REFERRAL REPORT

Report Date: April 21, 2020
Contact: Theresa O'Donnell
Contact No.: 604.673.8434
RTS No.: 13841
VanRIMS No.: 08-2000-20
Meeting Date: May 26, 2020

TO: Vancouver City Council
FROM: General Manager of Planning, Urban Design and Sustainability
SUBJECT: CD-1 Rezoning: 486 West 26th Avenue

North Elevation and East Elevation (26th Avenue and Lane)

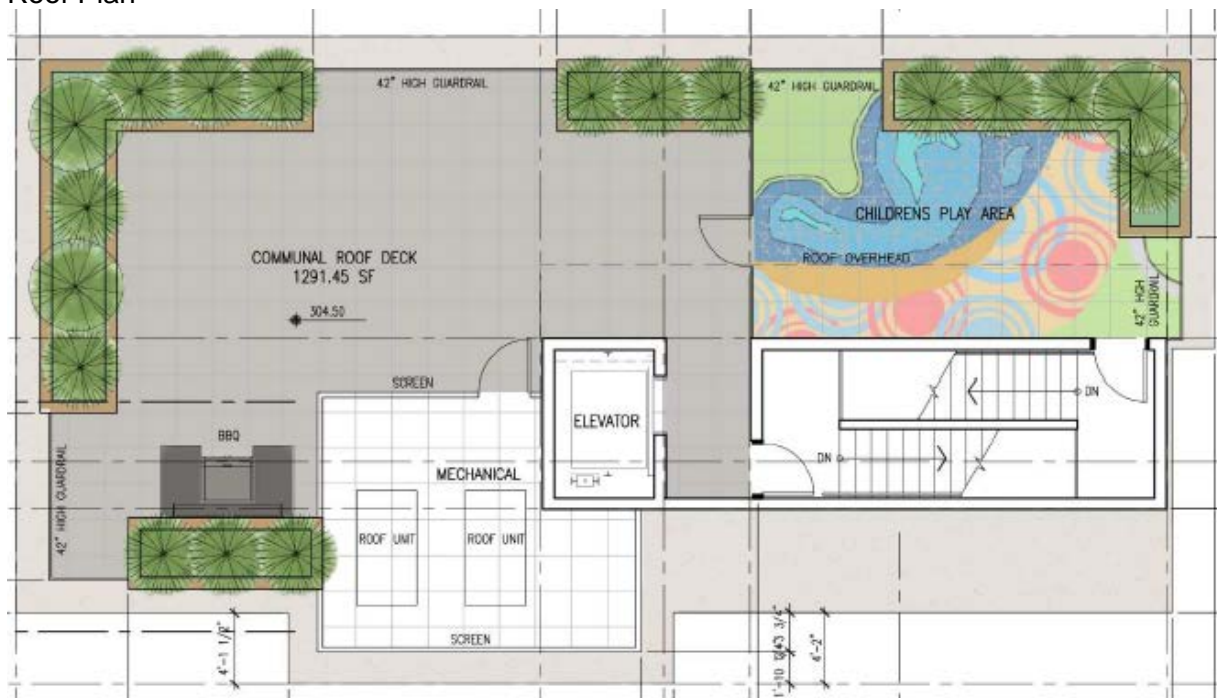
10. Design development to enhance the lane interface as follows:
 - (a) For units with entry facing lane, provide a 1.8 m (6 ft.) - 2.4 m (8 ft.) minimum rear yard setback to allow for a patio entry and planting bed.

Note to Applicant: This can improve the entrance to unit 106 from the lane.
 - (b) Incorporate landscape materials adjacent to the lane to include climbing plants, hanging plants from roof above, and/or shrubs and trees of suitable growing habit.
11. Design development to expand programming on third and fifth floor to include intensive green roof on flat roof portions, including urban agriculture plots, softening with planting at edges, other opportunities for common social interactions.

South and West Elevation (Interior lot line and Cambie)

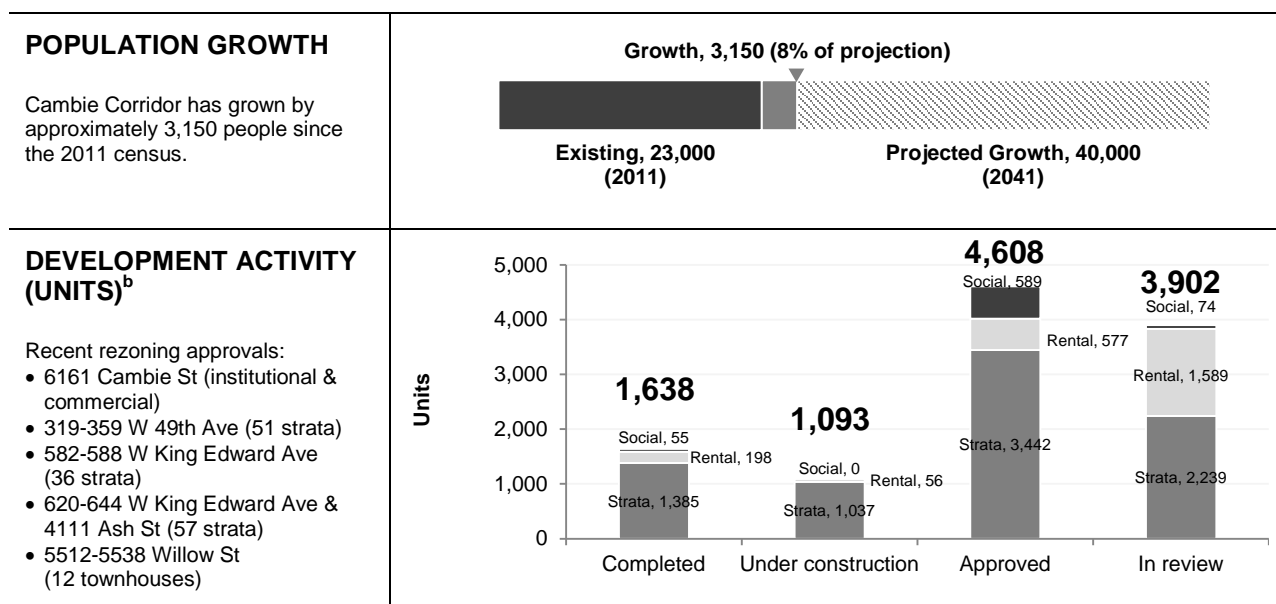
- (c) Enhance south elevation facing neighbouring courtyard.
- Note to Applicant: This can be achieved with colour, patterning, or robust planting given the southern orientation.
